Carisbrook Levee Overland Flow Questions May, 2021

Figure 4-23 Flood hydrographs in Carisbrook – January 2011

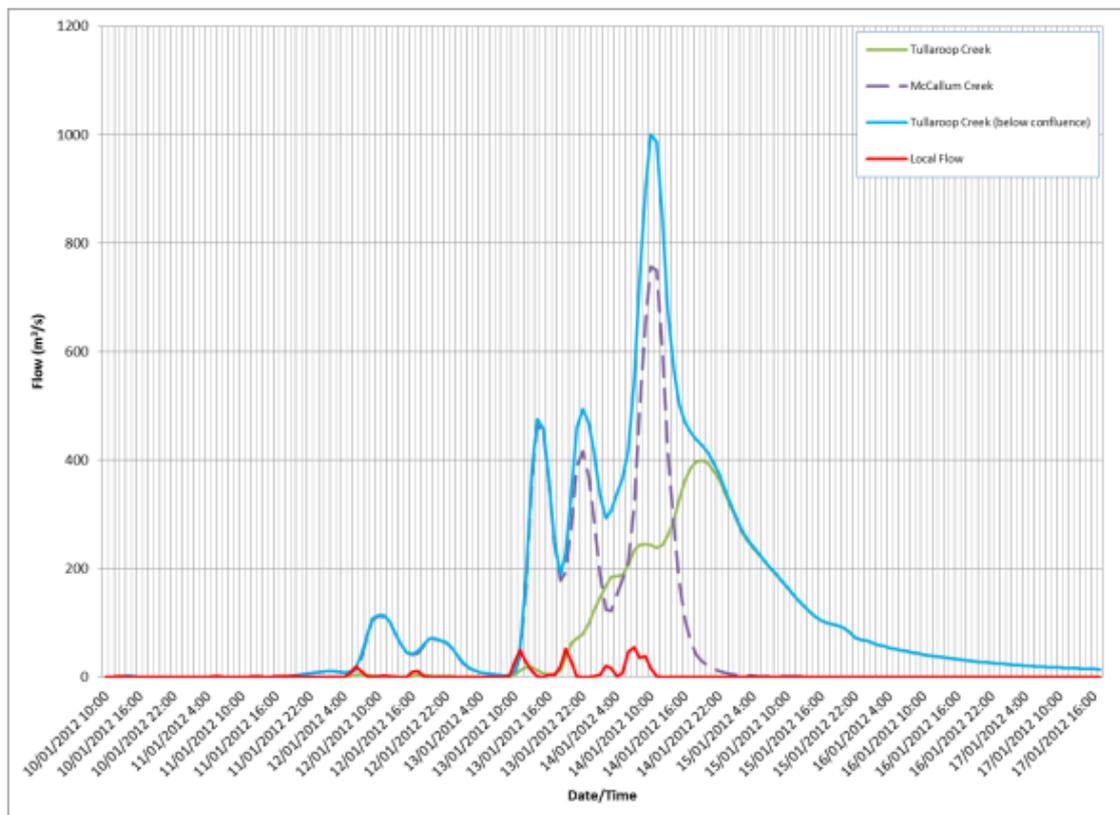
6. Where will 3000 to 4000 megalitres of water go in a 1 in 100 year flood as this happens in a very short time and by Water Technology figures only 535 ML/day can pass through the 2 culverts and by CMA figures based on the Lidar information only 94 ML can be held upstream of Pyrenees Highway.

It must be understood that the quoted figure of 4,000 ML/day is a peak flow rate that occurs at a particular point in time – it is not a flow rate that is continuous over a 24-hour period.

A simple analogy would be a car in the Bathurst 1000 that hits a top speed of say 300km/h. This does not mean that over the 8 hours of the event the car will have travelled 2,400km, because the peak speed of 300km/h is over a short duration within the overall event duration.

Table 4.23 in the Carisbrook Flood and Drainage Management Plan (see below) illustrates how the peak flows for the various flood components are of short duration.

The design of the levee (and the culverts under the Pyrenees Highway and the railway line) is based on flood modelling undertaken by acknowledged experts in hydrology (and then peer-reviewed). The flood modelling clearly demonstrates that the peak flow (for a 6-hour duration 1% AEP event) can be adequately catered for by the combination of above-ground storage and the above-mentioned culverts.
